COUNTY OF DANE DEPARTMENT OF ADMINISTRATION PURCHASING DIVISION

Subject: Addendum #3 to Bid# 119016 – Snow Removal Services

The following is to provide bid specification and scope of work clarification:

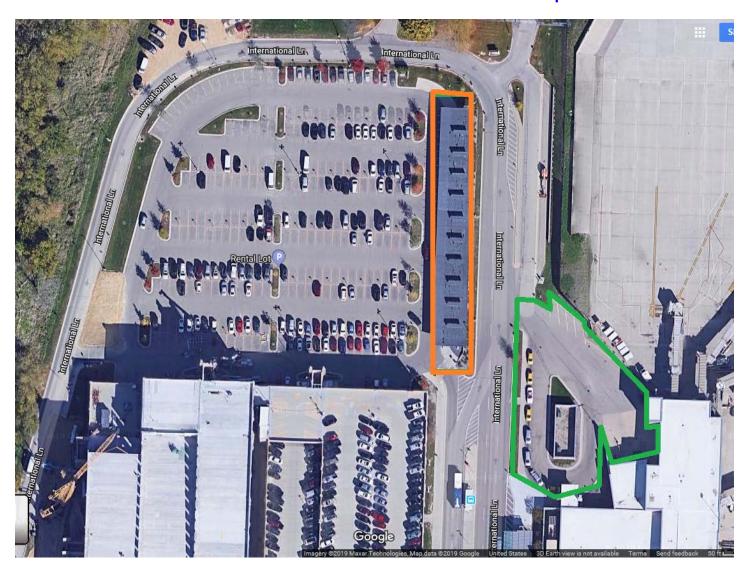
- 1. The parking ramp map and scope has been revised by removing the toll booth area. The toll booth area is already included on the 3 - Daily Surface Lot section. This change is indicated on the map attached to this addendum.
- 2. The pricing section for 2 Parking Ramps East and West area has been revised. The revision includes removing the Snow Hauling section and adding a "Per Truck Load Dump" section.
